SUBMISSION : DRAFT AMENDMENT TO NSDCP 2013 | WARD STREET PRECINCT MASTERPLAN

SUBMISSION ON DRAFT AMENDMENT TO NSDCP 2013 WARD STREET PRECINCT MASTERPLAN

Prepared for
PODIA
17 May 2021

Figure 2: Council's initial Policy Position as per North of Centre Strategy

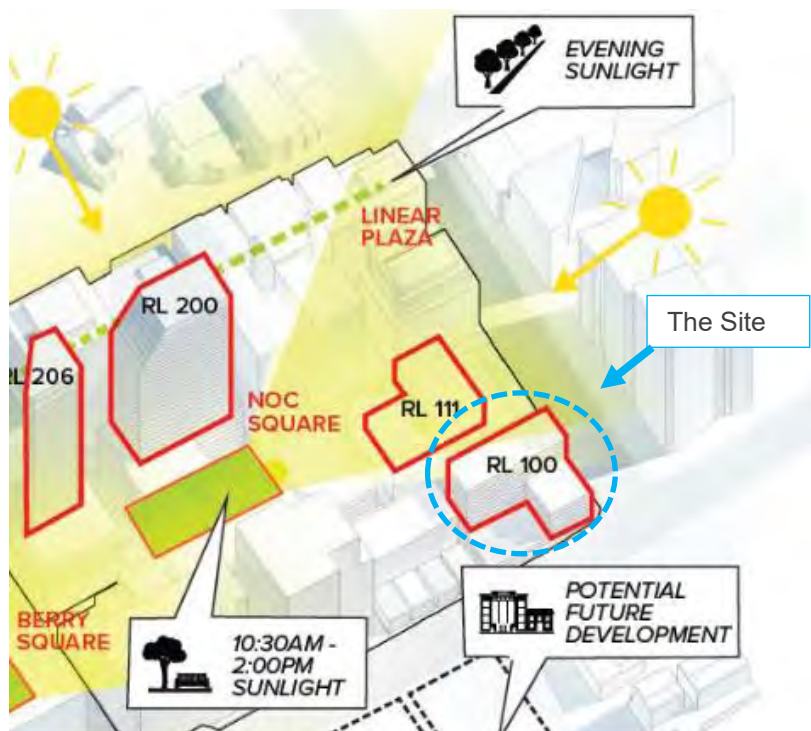
At that time, Council's policy position was that solar access to the square was to be protected between 10:30am – 2:00pm (refer to **Figure 2**). This was an accepted and clear standard.

Figure 3: Building Envelope – compliant with draft DCP Amendment

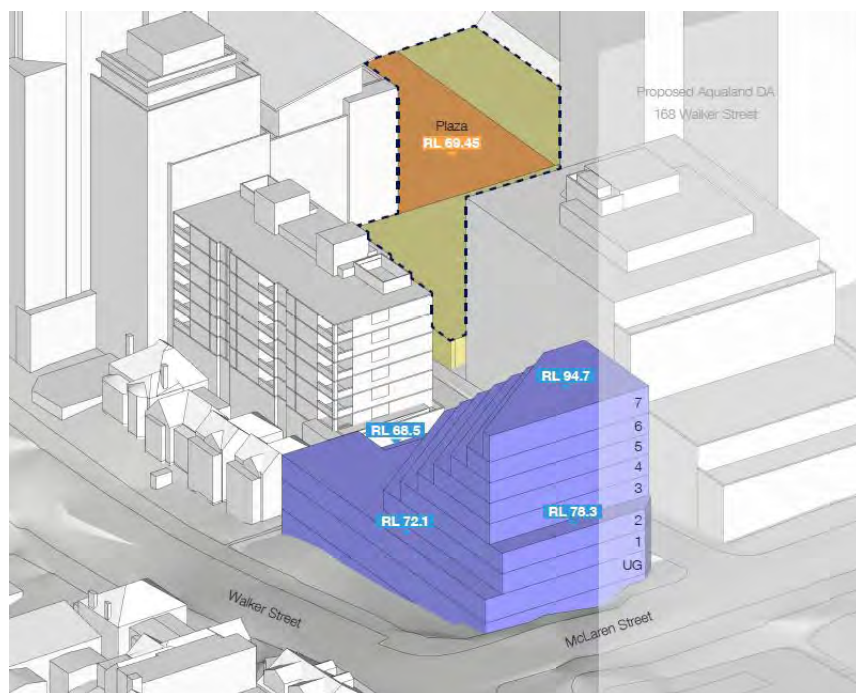
Figure 3 on page 14 below illustrates a building envelope that is compliant with Council's draft DCP controls. The resultant configuration is an inferior and irregular built form that ranges between 3 storeys and 7 storeys, where the upper three levels include floor plates of 160m²-300m², creating bad urban design outcome that is costly and presents difficult floorplates to design. Furthermore, the envelope in **Figure 2** is incapable of complying with SEPP 65 (ADG controls). Accordingly, the DCP controls completely sterilize the site making it undevelopable.
